June 22, 1984

This is in response to the Safety Evaluation Report (SER) dated April 30, 1984 (Log No. 1503) which addressed the proposed modifications to the Toledo Edison's Davis-Besse Nuclear Power Station, Unit 1, Reactor Trip System. These modifications were developed in response to the Required Actions Based on Generic Implications of Salem ATWS Event (Generic Letter 83-28, Log No. 1322 dated July 8, 1983).

REACTOR TRIP BREAKER
SHUNT TRIP CIRCUIT MODIFICATION
DAVIS-BESSE UNIT NO. 1

REACTOR TRIP BREAKER ARRANGEMENT			
THE TOLEDO EDISON CO. DAVIS-BESSE NUCLEAR STATION UNIT NO. 1			
Δ	5	General	AMK
▽	3	Obs./A./PM	BY
			CHG
			APPR
DRAWN BY	JLH	APPROVED BY	
CHECKED BY	AMK		
DATE	4-17-84		
		NO.	26372-1

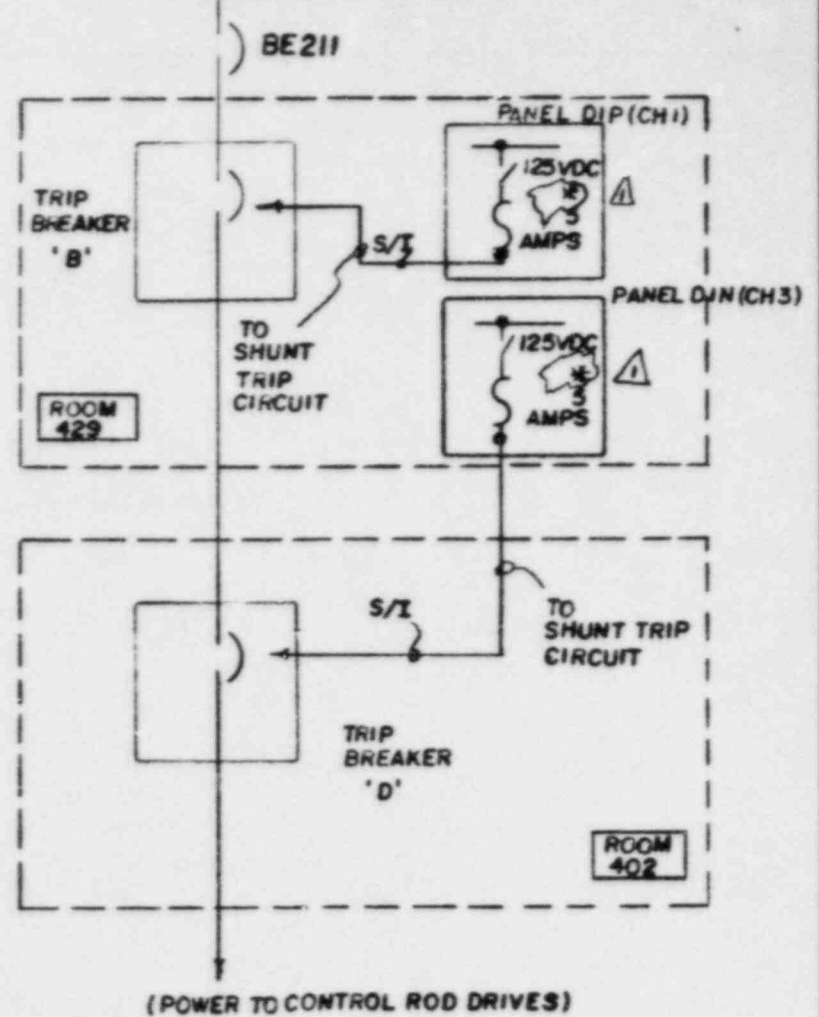
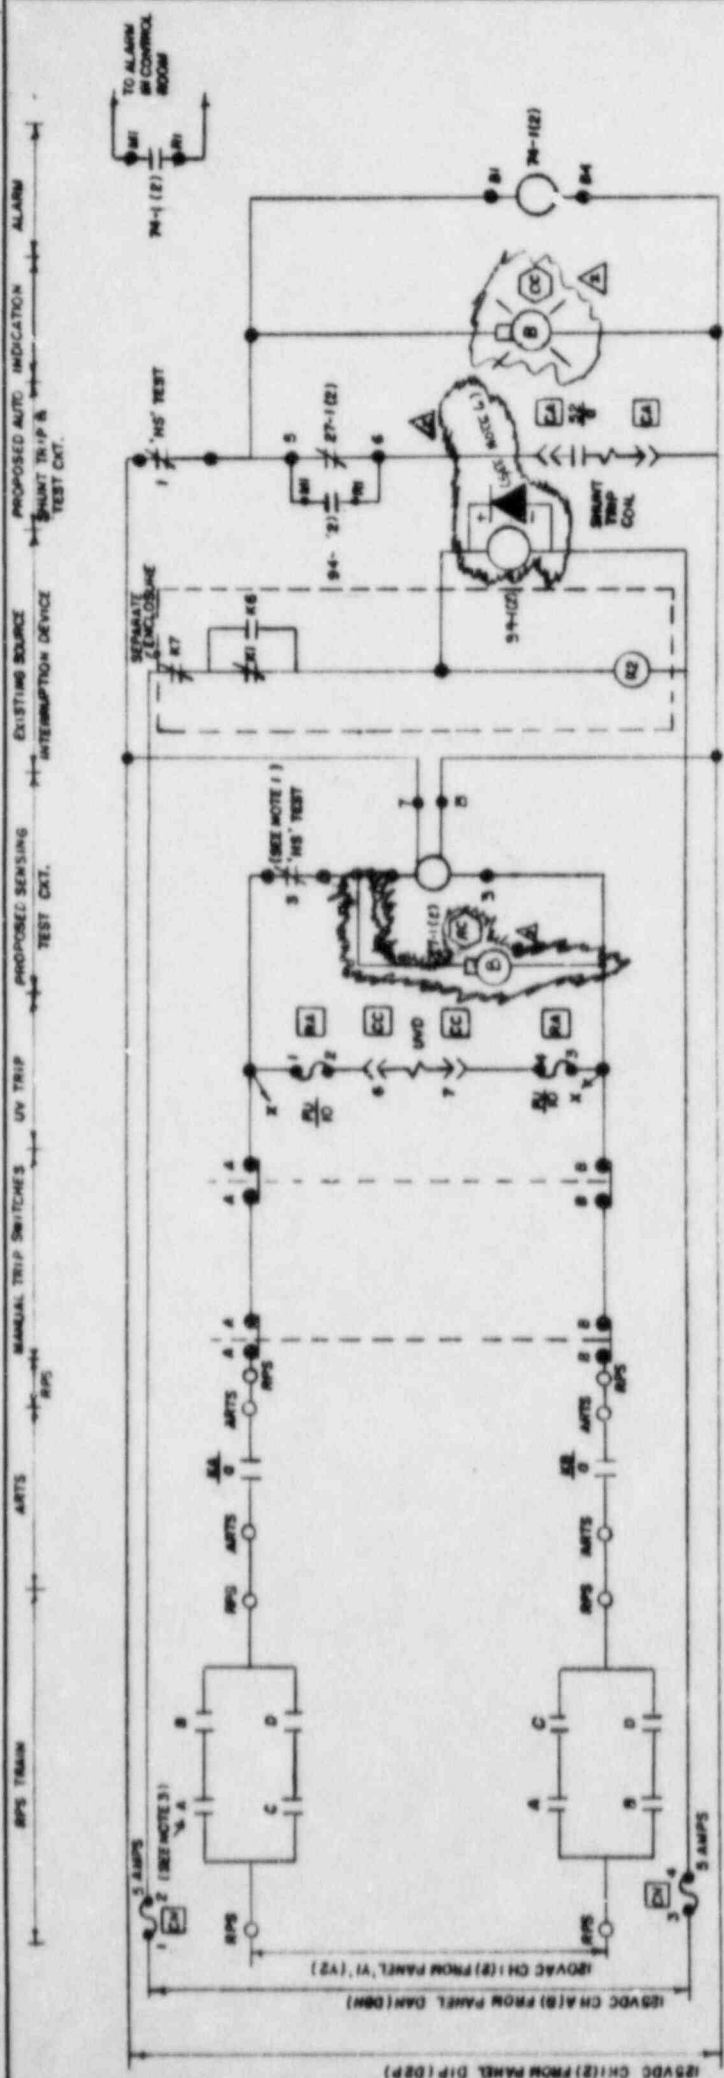
Power Supply
(Sketch No. 26372-1)

Power to shunt trip attachment of each reactor trip breaker (RTB) will be provided from a separate Class 1E power source. The cable carrying the control power will be Class 1E qualified and the associated conduit run will be installed to Seismic I category.

Control power to the non-safety related source interruption device (SID) will remain from the existing non-safety related 125 VDC source. Isolation between the non-safety related and the safety related wiring has been provided within the breakers and the cable routing outside the breakers.

SCHEMATIC DIAGRAM
REACTOR TRIP CIRCUIT BREAKER

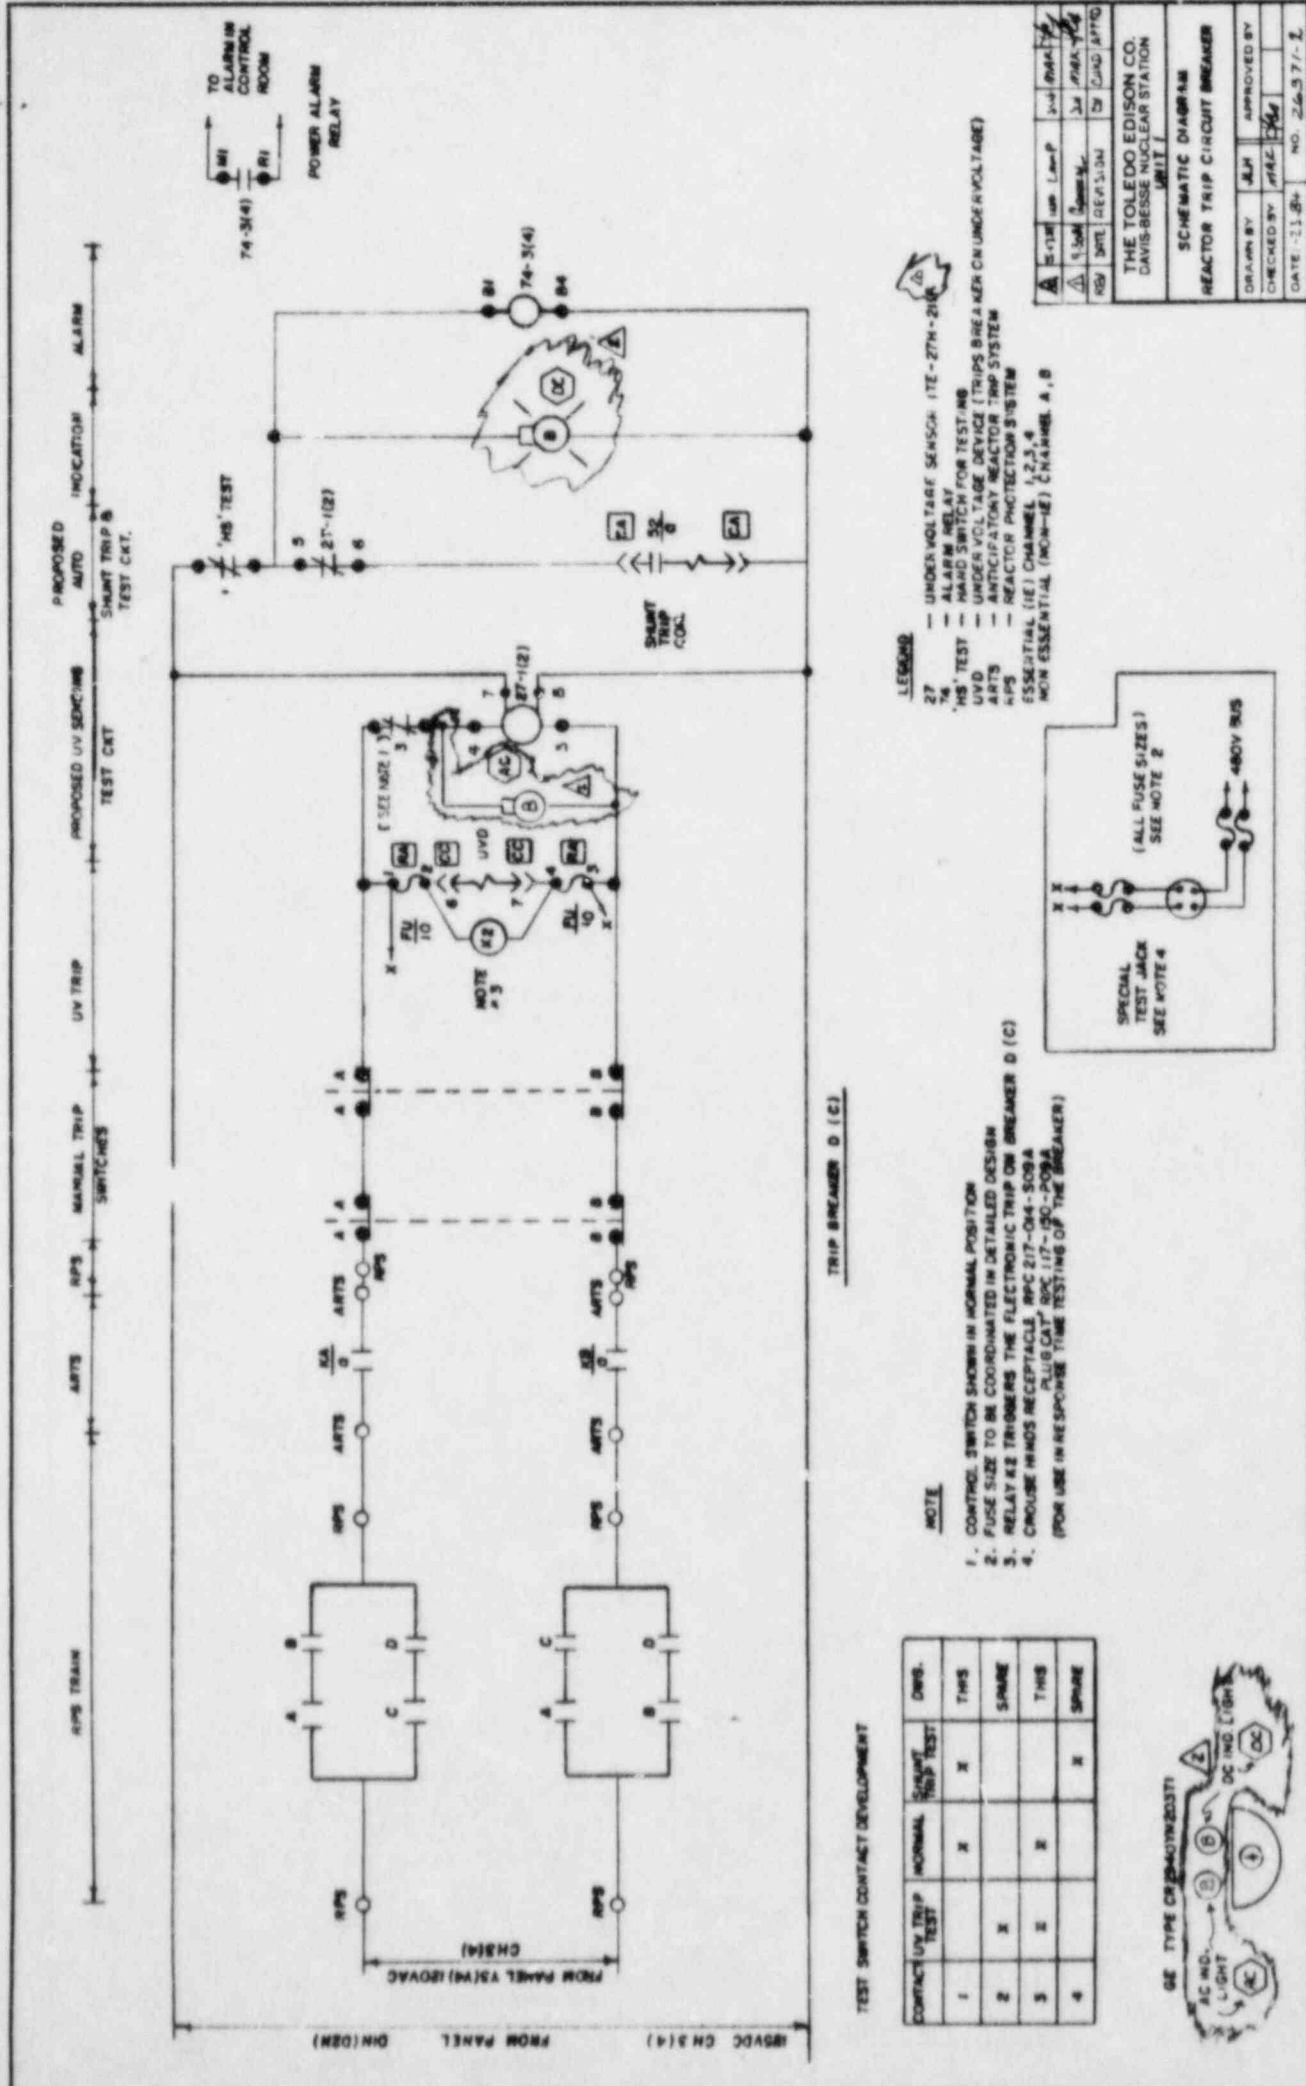
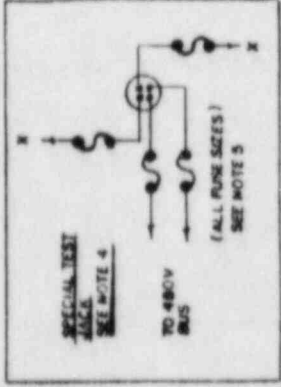
UV Sensor

In the modified design the Model ITE-27H-211R relay, operable from a Class IE 125 VDC power source, is used to actuate the shunt trip attachment.

Shunt Trip Attachments
(Sketch Nos. 26370-2, 26371-2)

In the modified design, the shunt trip attachments will be designated as safety related. The shunt trip attachments in all four breakers will be seismically qualified, based on the qualification testing of similar attachments in AK-2 breakers of Unit Electric Control, Inc. We will assure that the test results in this report are acceptable according to the industry standards and applicable to the RTBs at DBNPS Unit No. 1.

Indicating Lights
(Sketch Nos. 26370-2, 26371-2)

Two indicating lights are provided in the modified design. One will be lit when power is available for the shunt trip attachment, and the second will be lit when power is available for the under voltage sensor.

Isolation of non-safety related SID from the 1E shunt trip will be provided through the coil to contact isolation of a Class 1E relay (94). (see drawing 26370-2)
